Subject: Comments on June 1 Missing Middle Draft Standards

Comments On:
City of Berkeley
Zoning Ordinance Revision Project
Objective Standards for Missing Middle Housing
May 27th, 2022

Re: Solar Access in Middle Housing Objective Stds;

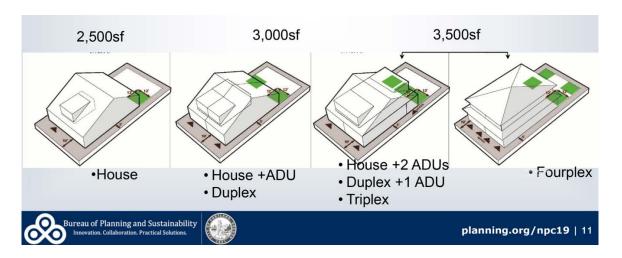
- 2. Based on our high-value market, developers will likely deliver the largest, most expensive home/unit allowed by the zoning, leaving many of the new homes outside of an attainable price point.
- 3. The increase in number of units on a lot counters this a bit, but there are still not a high enough number of units allowed on smaller lots.
- 2. What: Use Portland as an example/reference point.
 - Compare this to Portland's very well refined approach, which caps square footage much lower to achieve attainable, house-scale buildings (See image below):

Fourplex: 3,500 square feet max per lot (875 sf/unit)
 Triplex: 3,000 square feet max per lot (1,000 sf/unit)
 SF home: 2,500 square foot max per lot (2,500 sf/unit)

2. This approach also caps heights at 2 stories maximum.
